ITEM NUMBER	13.3
SUBJECT	Response to Post Gateway Review for the Planning Proposal for land at 55 Aird Street, Parramatta
REFERENCE	RZ/18/2015 - D05830960
REPORT OF	Project Officer-Land Use Planning
OWNER	Aird Lynx Pty. Ltd.
APPLICANT	Statewide Planning Pty. Ltd.

To seek Council endorsement of a draft submission to the Department of Planning and Environment on a Gateway review request for the Planning Proposal for land at 55 Aird Street, Parramatta. A review is being sought by the applicant of the proposed floor space ratio imposed by the Gateway determination conditions.

Planning Proposal (Department Ref: PP_2017_COPAR_012_00): to alter the height of building and floor space ratio controls at 55 Aird Street, Parramatta.

Figure 5 Typical floor plan (Source: Applicant's Urban Design Report)

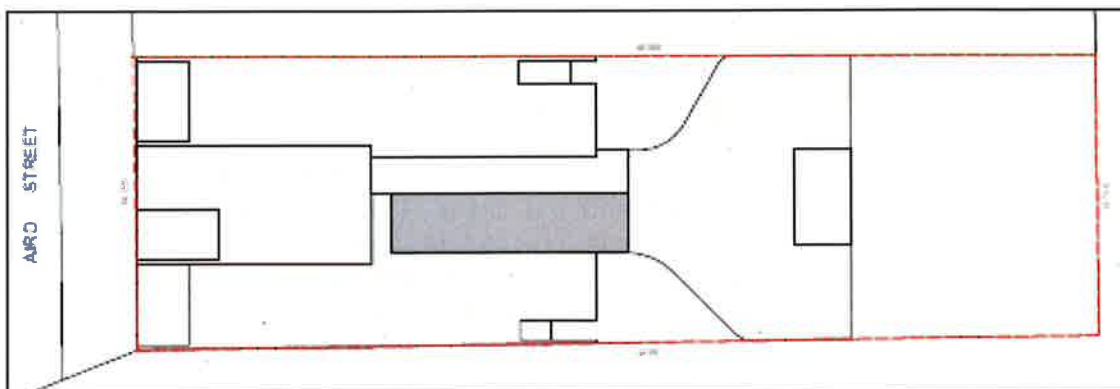
12. The Applicant's Urban Design Report does not provide clear floor plans, however the built form indicated demonstrates that compliance with the SEPP 65 Apartment Design Guidelines for building separation cannot be achieved. Light wells are relied upon (see Figure 5) as a means of achieving natural light and ventilation which is inconsistent with the objectives of the ADG. **To achieve a tower form zero lot side setbacks are required and 120m high blank walls are utilised in order to respond to building separation and privacy requirements. As a result, the onus is placed on neighbouring landowners to provide the required setbacks.**

30. Even with an FSR of 6:1 the floor plan presented in the Urban Design Report, see Figure 5, if retained will result in compromised apartments that fail to comply with the objectives of the ADG. If the floor plate presented in the Urban Design Report was to be reduced as there would be more opportunity to comply with the ADG and it would provide for better built form outcomes.

Figure 6 Amalgamation opportunities (Source: Council's GIS)

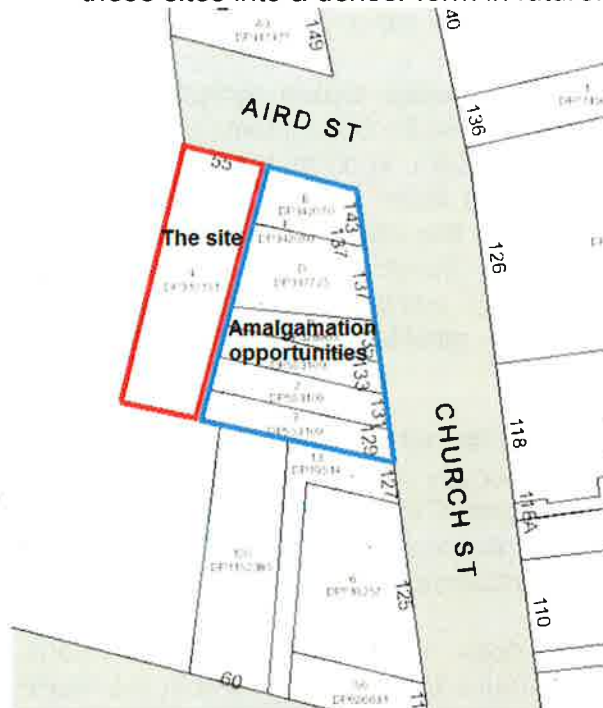
13. The planning proposal has been assessed by Council's urban design team and it is held that based on the reference design submitted by the applicant that the site is too small to provide an acceptable tower form at the density being sought (15:1).
14. The sites along the eastern boundary of the subject site fronting Church Street (see Figure 6, outlined in blue) are 1-3 storey retail tenancies that are separately owned. Although the sites are smaller than the subject site, Council officers do not discount the potential interest of the landowners to develop these sites into a denser form in future.

15. The CBD Planning Proposal envisages smaller sites such as 55 Aird Street and the developments fronting Church Street to amalgamate to improve development outcomes. If the sites are to progress separately seeking tower forms access to the sites will be compromised and blank walls will be utilised extensively. The applicant's Urban Design Report details a 38 storey building fronting Aird Street with a 120 metre blank wall facing Church Street. It will not be possible for all sites to achieve inter tower separation and setbacks in accordance with ADG requirements. There is opportunity to amalgamate the sites (outlined in red and blue in Figure 6).

16. Should 55 Aird Street and the sites along Church Street be amalgamated compliance with Council's DCP and the State Government's ADG could be more readily achieved. A single built form would cover all 7 sites and the site would be large enough to provide the necessary setbacks for compliance and a higher level of amenity can be achieved for future residents at a higher FSR. If the sites aren't amalgamated setbacks for each individual site will be required.

Figure 7 Development options for neighbouring sites (Source: Urban Design Report)

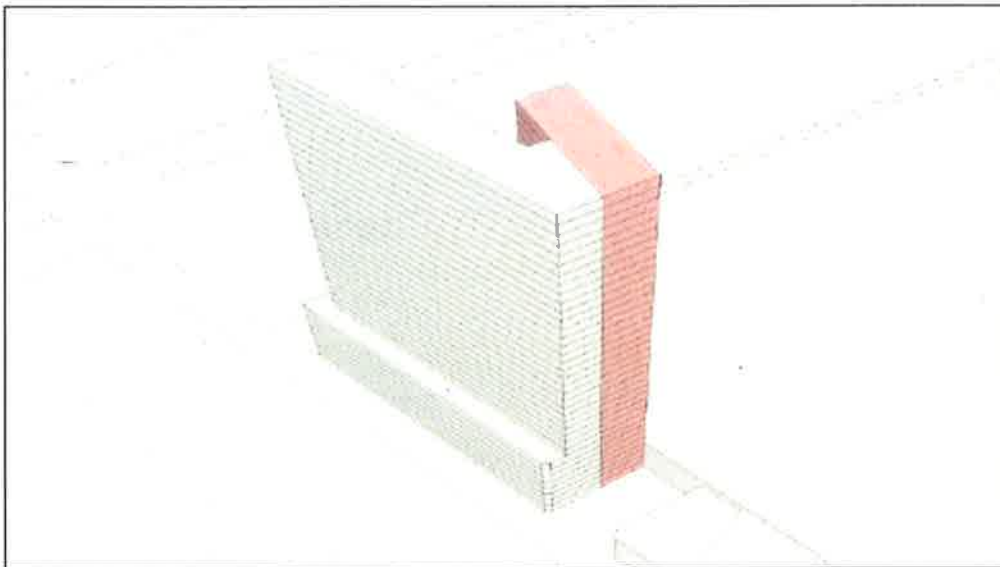
17. The Urban Design Report submitted by the applicant includes indicative building envelopes on the adjacent sites to the east along Church Street, see

Figure 7. The design has been prepared with the assumption that the other landowners along Church Street are able to amalgamate. Due to the zero lot setback of 55 Aird Street the Church Street building envelope is unable to develop a similar form. A minimal inter tower setback is provided requiring blank walls for both towers. The Church Street envelope is also required to provide a 6m setback to Church Street. Tower setbacks are essential to reduce wind tunnels and provide a comfortable human scale for pedestrians at street level. The indicative building envelopes presented at Figure 7 demonstrate the onus placed on the neighbouring sites to provide a setback between the two tower forms.

Figure 8 Development options (Source: Council modeling)

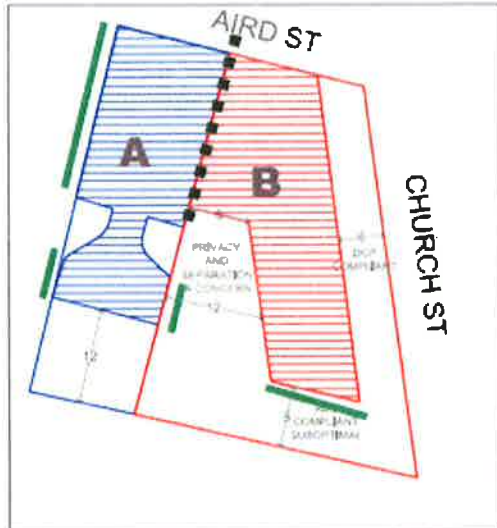
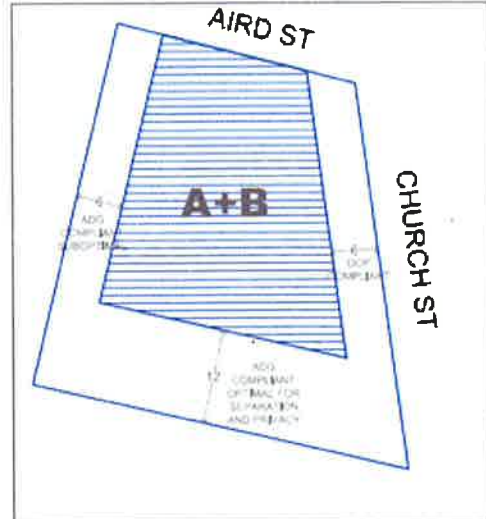
18. Figure 8 demonstrates how the sites along Church Street could be developed if Council adopts FSRs of 20:1 or 11.5:1. The Proponent's Scheme is informed by the Urban Design Report submitted with the original planning proposal. There is 12 metres provided between apartments in towers A and B creating privacy concerns, the units at the rear would receive limited sun access and ventilation. This scheme is non-compliant with the ADG, features 38 storey blank walls and provides minimal front, side and rear setbacks.
19. Option 1 demonstrates a built form that could be accomplished should the subject site amalgamate with the sites along Church Street, reaching an FSR of 11.5:1 including design excellence (in keeping with CBD PP). Site amalgamation could result in a development that includes no blank walls, appropriate setbacks in keeping with the DCP, a defined podium with tower

setback and improved development potential for all sites. The design at Figure 8 complies with the ADG providing ventilation, solar access and privacy.

Figure 7: Building envelope study across the block

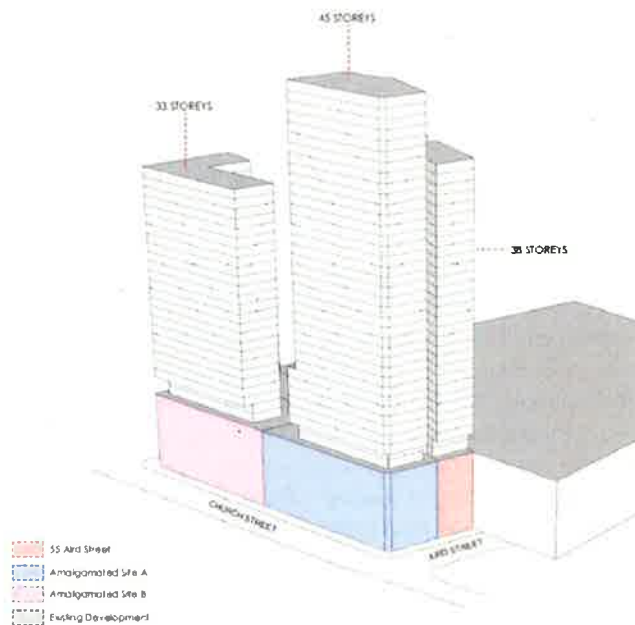
The Urban Design Report included a building envelope study that explored the potential development outcomes that result from the development of 55 Aird Street on adjoining sites. As part of the study an analysis of the ideal building heights for each of the potential development sites was completed. The study also tested the impacts of different upper level setbacks to Church Street in order to determine which would produce the best urban design outcome and development potential.

The heights of adjoining sites were designed to strengthen the Church Street and Aird Street corner with an urban marker. This also created equitable development potential across all sites and created an attractive and distinctive city skyline defined by tall slender towers.

While an amalgamated site makes development proposals easier to assess, the block has been unable to amalgamate and there appears to be little incentive to achieve this under the proposed controls. The extensive work that has gone into envelope testing has demonstrated that a small site in this location and context has the ability to achieve greater density than allowed by the Gateway conditions and still achieve a good planning outcome.
